URBAN DESIGN COMMISSION APPLICATION

RE: **CMFG Life**
5810, 5910, and 5710 Mineral Point Road
Major Alteration to an Approved Comprehensive Design Review (from February 9, 2022)

Attached please find revised design materials for consideration of a Major Alteration to the Approved Comprehensive Design Review for **CMFG Life**, located at 5810, 5910, and 5710 Mineral Point Road.

11.4 TruStage - Internally Illuminated Channel Logo & Letters - East Elevation

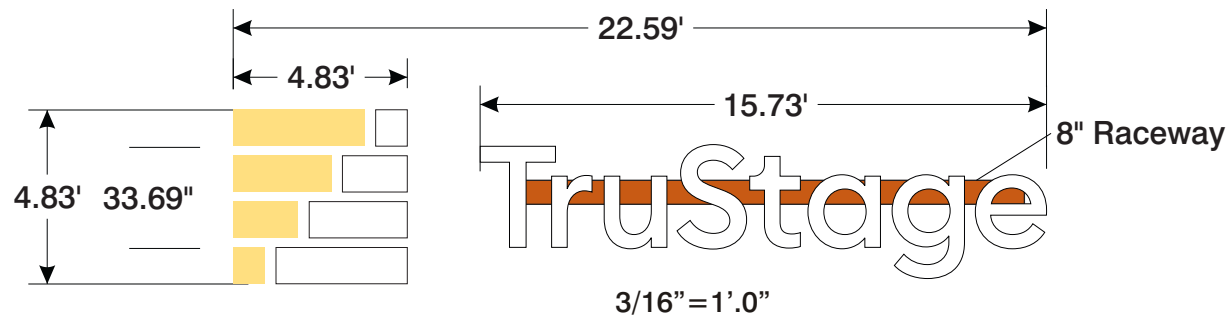
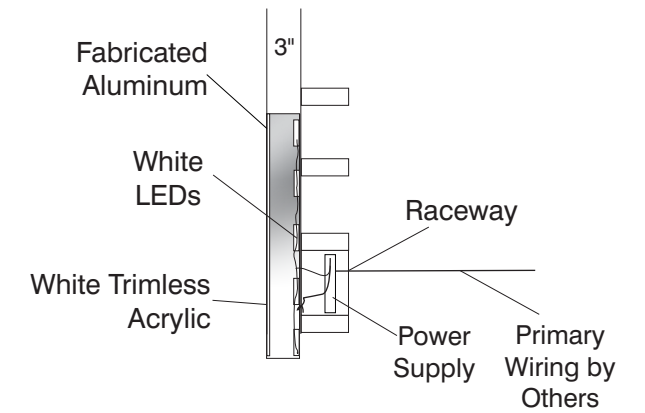
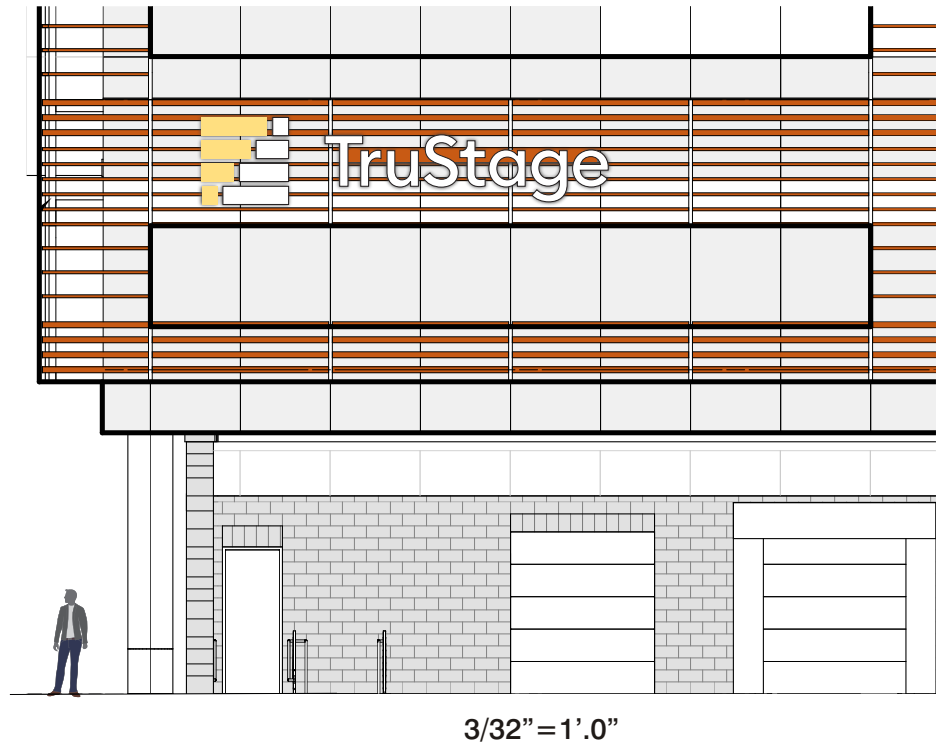
2. Request an exception for two signs to be installed on the rail detail of the architecture (as originally suggested by the UDC at their February 9, 2022 meeting). These architectural features are not qualifying signable areas. Upon further review of the completed building and its surrounding area, the client agrees that the lower signage placement is more vehicular and pedestrian friendly and, more consistent with neighboring signage.

- Allow for an exception to install sign on a non-qualifying signable area
- Up to 73.65 sf2 (reduced from 120 sf2) (not to exceed 30% of signable area)
- **Internally illuminated letters and logo to match proposed wall signs (proposed at 73.65 sf2)**
- Illuminated using white LED
- Final copy: TruStage with Logo icon

| 11.4 East Elevation | 31.07 – WALL, ROOF AND ABOVE-ROOF SIGNS | Up to 73.65 sf2 individual letters (not to exceed 30% of signable area) Internally illuminated | Code Complaint | Request approval for: 1. Internally illuminated letters/logo 2. NTE 73.65 sf2. 3. Located on rail system above 2 nd floor. |

14.1 TruStage - Internally Illuminated Channel Logo & Letters - West Elevation

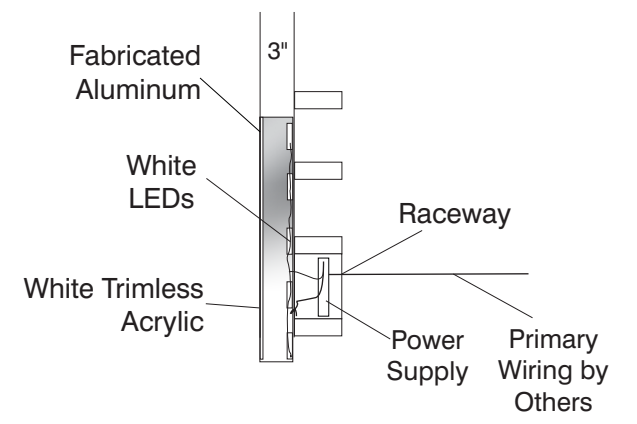
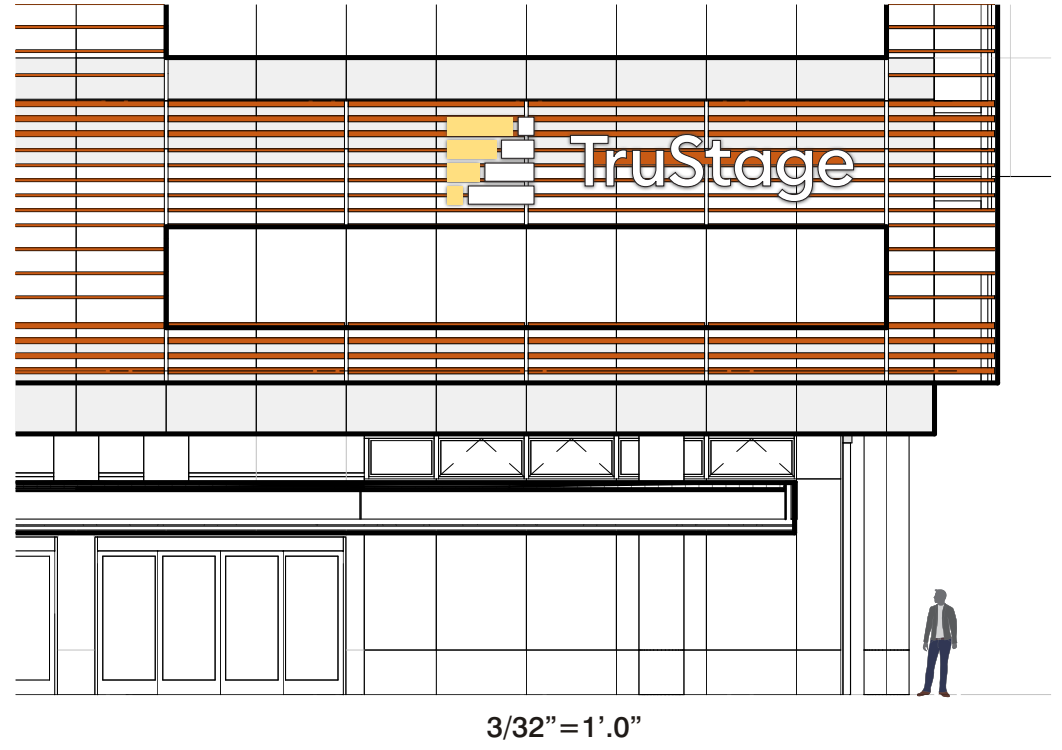
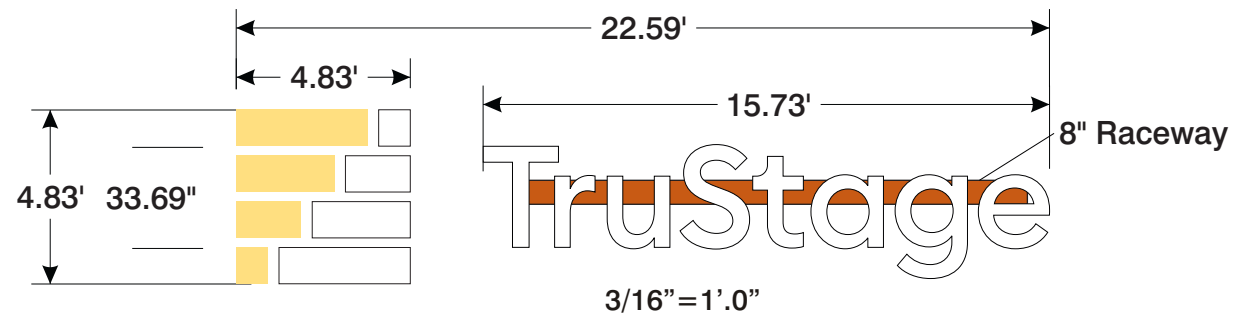
3. If not considered adjacent to a street frontage or customer parking lot of 33'-0" or more in width, we request an exception for West elevation letters to be placed on this elevation.

- Allow for an exception to install sign on a non-qualifying signable area
- Up to 73.65 sf2 (reduced from 120 sf2) (not to exceed 30% of signable area)
- **Internally illuminated letters and logo to match proposed wall signs (proposed at 73.65 sf2)**
- Illuminated using white LED
- Final copy: TruStage with Logo icon

| 14.1 West Elevation | 31.07 – WALL, ROOF AND ABOVE-ROOF SIGNS | Up to 73.65 sf2 individual letters (not to exceed 30% of signable area) Internally illuminated | Not included in original and Approved CDR. | Request approval for: 1. Internally illuminated letters/logo 2. NTE 73.65 sf2. 3. Located on rail system above 2 nd floor. 4. Allow for exception if not considered adjacent to a customer parking lot of 33'-0" or more in width. |
